PL-NF-97-005
Rev. 3

Susquehanna SES Unit 2 Cycle 9

CORE OPERATING LIMITS REPORT

June 1998

Average Planar Exposure (MWD/MTU)
MAXIMUM AVERAGE PLANAR LINEAR HEAT
GENERATION RATE (MAPLHGR) VERSUS
AVERAGE PLANAR EXPOSURE
SPC 9X9-2 FUEL
FIGURE 2.2-1

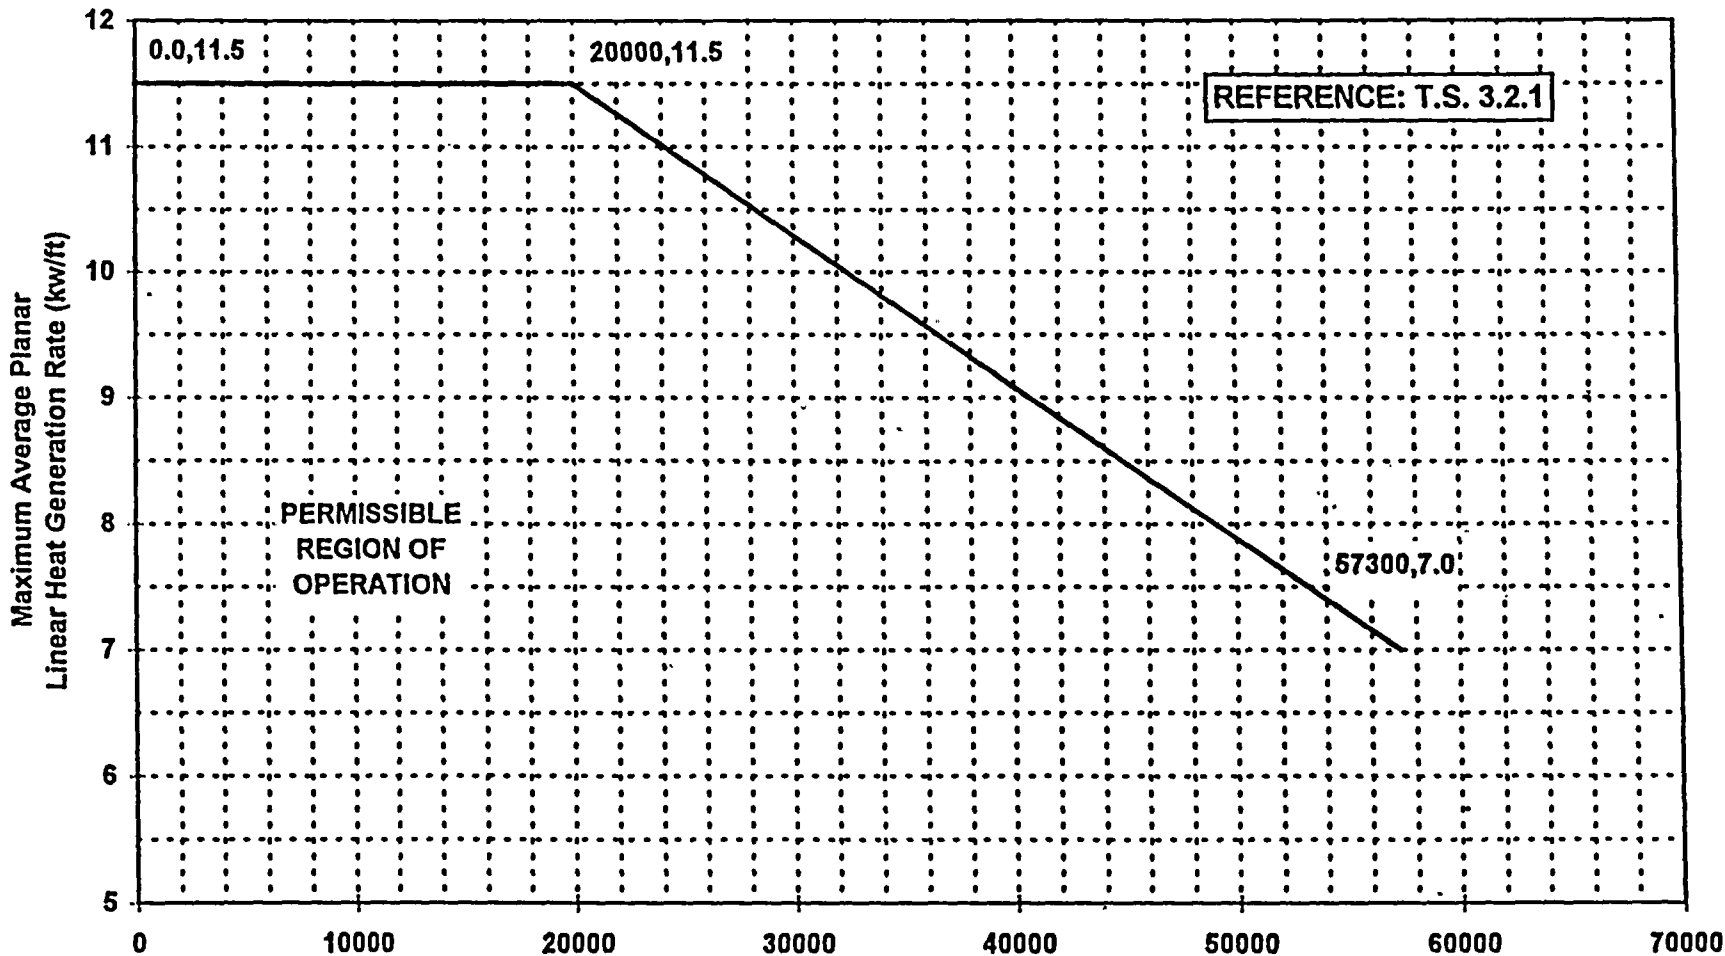
1.0	Removed Single Loop from the core operating limits included in this report.	
	2.0	Revised Figures 2.2-1, 2.2-2, 2.2-3 to correct a typographical error on the figures (i.e., "PERMISSABLE" to "PERMISSIBLE")

TWO LOOP FLOW DEPENDENT MCPR OPERATING LIMIT
(BOC TO EOC)
FIGURE 4.2-1A

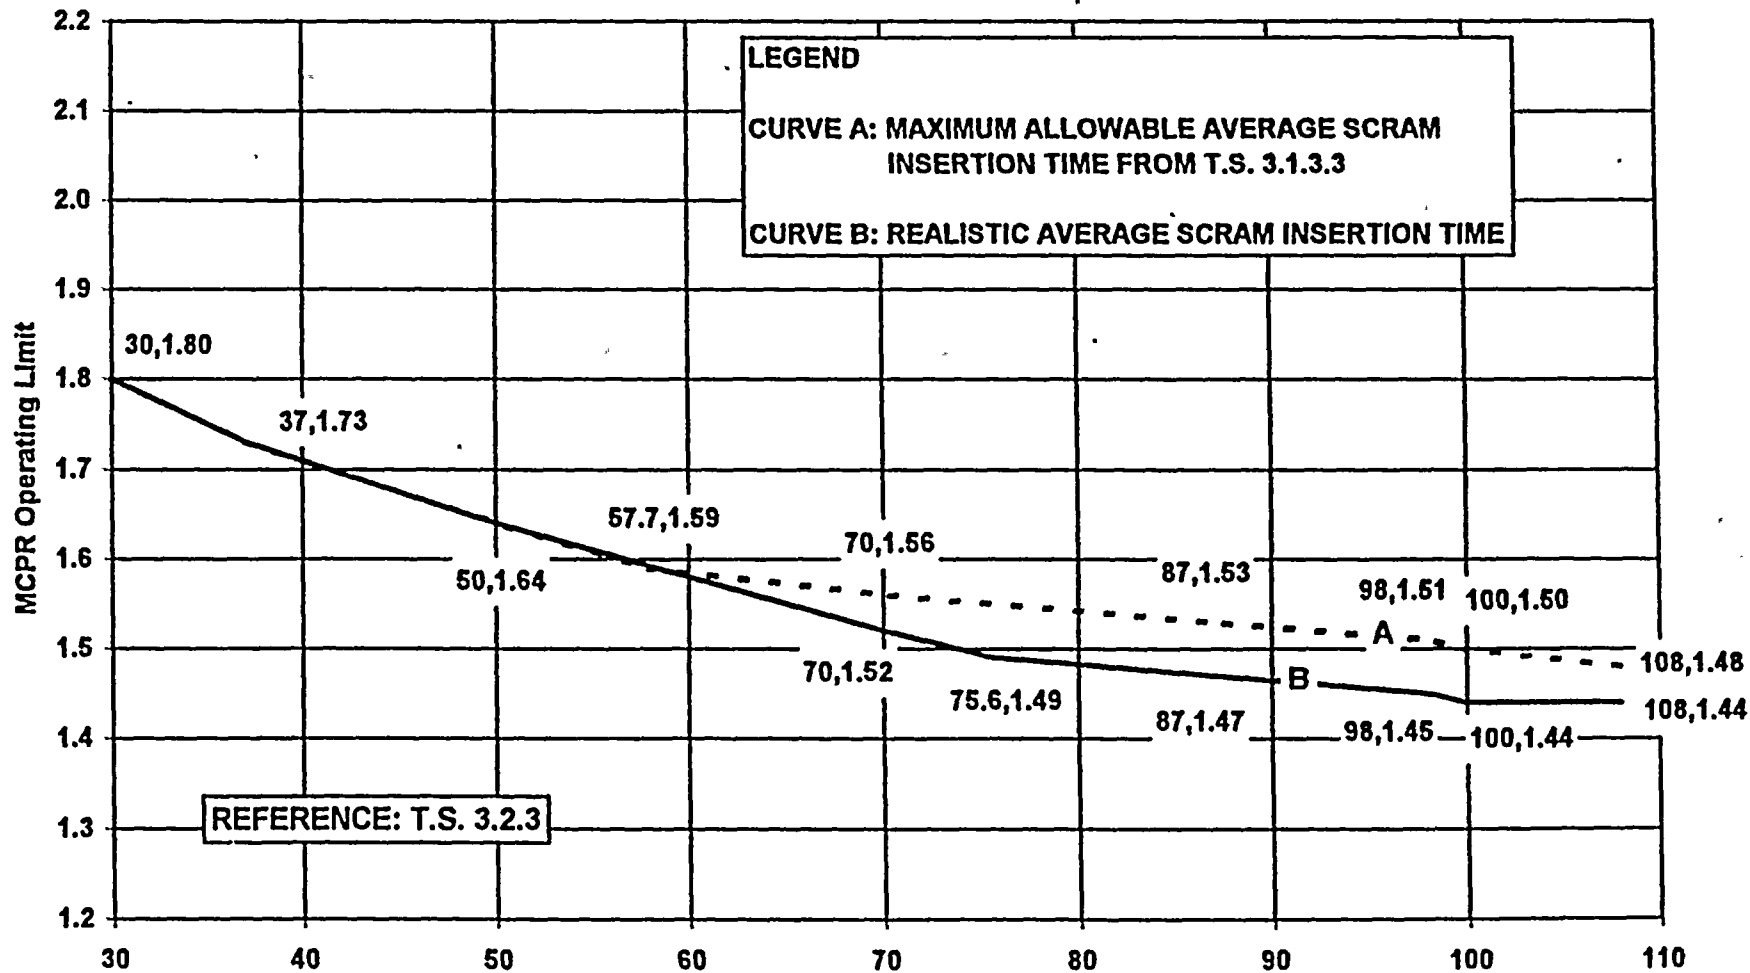
PP&L		CORE OPERATING LIMITS REPORT REVISION DESCRIPTION INDEX	
Rev. No.	Affected Sections	Description/Purpose of Revision	
3		<p><u>Revised MCPR Operating Limits</u></p> <p>The Two Loop BOC to EOC power and flow dependent MCPR Operating Limits were revised, and the Single Loop MCPR Operating Limits were removed from the COLR. The revised MCPR Operating Limits are documented in Reference 1.</p>

4.0	Revised MCPR OL Figures 4.2-1A, 4.2-2A, and 4.2-4. MCPR OL Figures 4.2-3A and 4.2-3B were removed, and Figure 4.2-3 was added. Table 4.3-1 was revised to include a new set of Realistic Scram Insertion Times.

Average Planar Exposure (MWD/MTU)
LINEAR HEAT GENERATION RATE (LHGR) LIMIT
VERSUS AVERAGE PLANAR EXPOSURE
SPC 9X9-2 FUEL
FIGURE 5.2-1

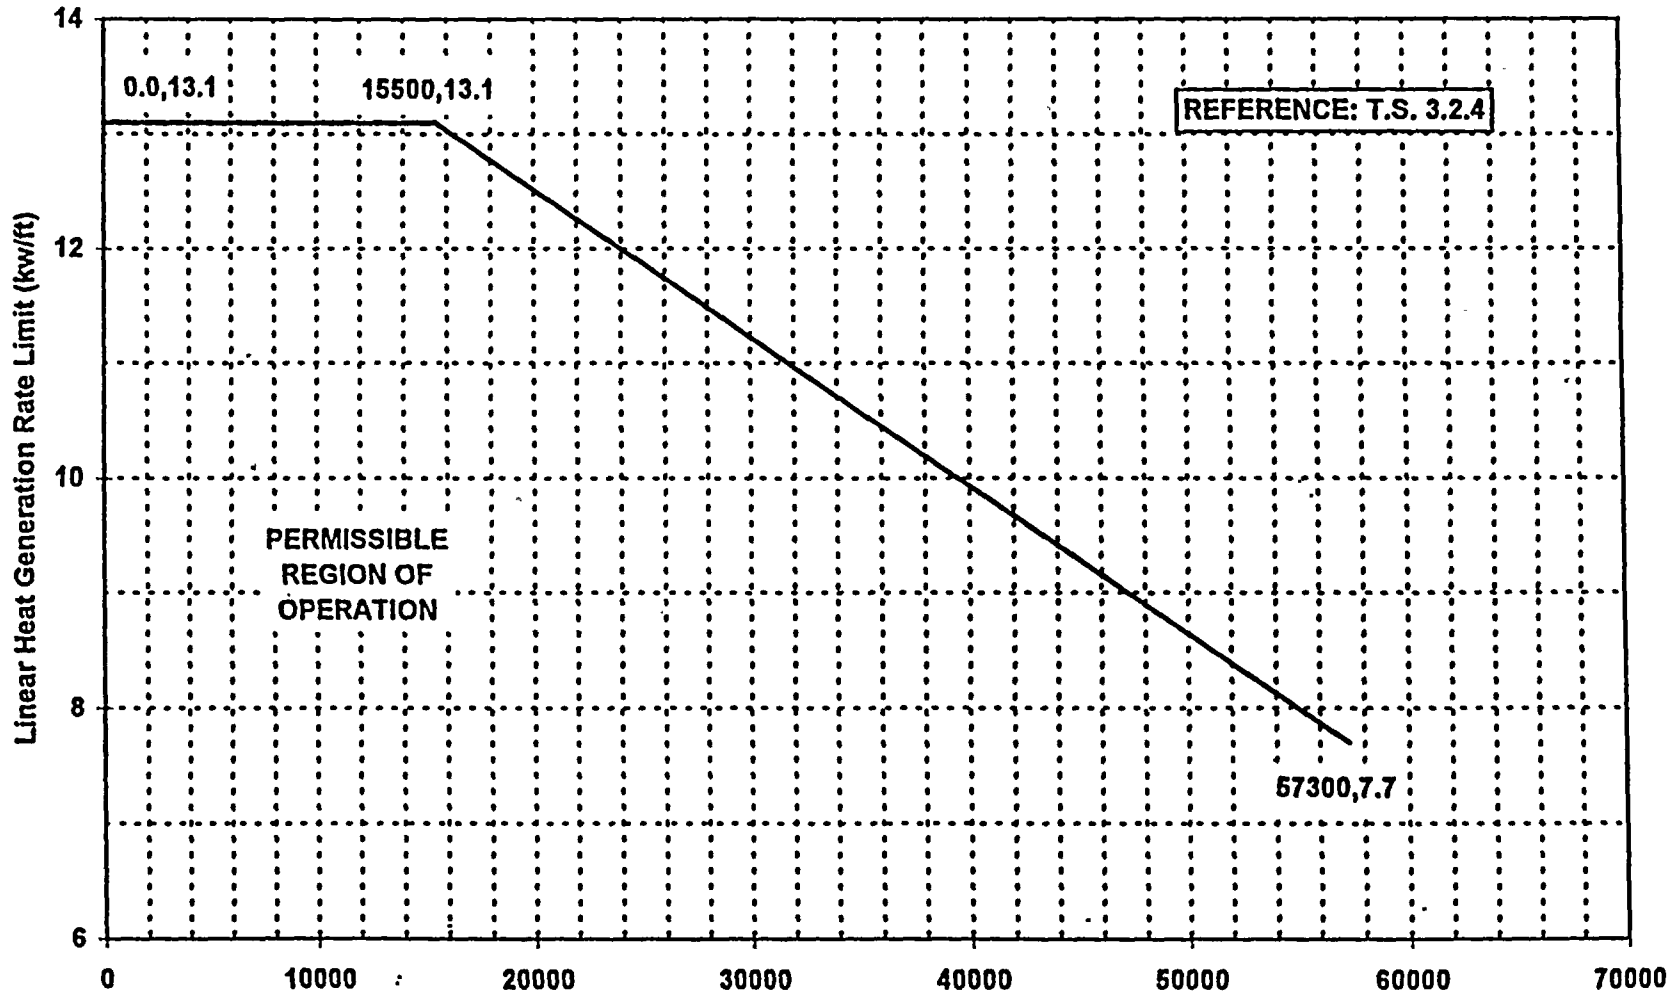
5.0	Revised Figures 5.2-1, 5.2-2, 5.2-3 to correct a typographical error on the figures (i.e., "PERMISSABLE" to "PERMISSIBLE")	
	6.0	Removed Single Loop operating limits and added a note to the section stating Single Loop operation is prohibited.
